GTS NEWSLETTER

TASKI ergodisc water tank Art.-No. 8504390

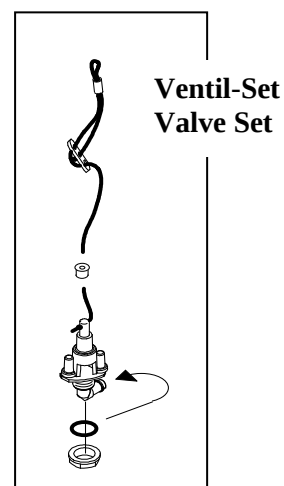
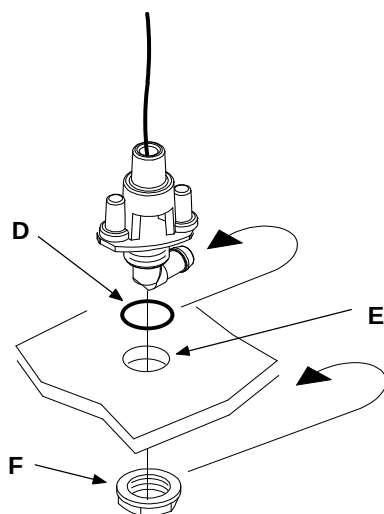
For the **water tank ergodisc** some modifications were made. On the locking part, 2 bolts (A) and 2 pedestals (B) are integrated in the tank body.

These two changes are representative for the „new tank“ identification. As generally known for these article-category, there are no serial numbers available!

The most important change of the valve is the improved assembling.

- The complete pre-assembled valve including gasket (D) has to be mounted through the bottom hole (E)
- The valve is fixed by the hexagon nut (F) from the bottom
- **New spare parts:**

The new valve set 4126698 (80116-34) can not be assembled in old tanks.

The previous valve set 4122310 (80116-30) can not be assembled in new tanks!
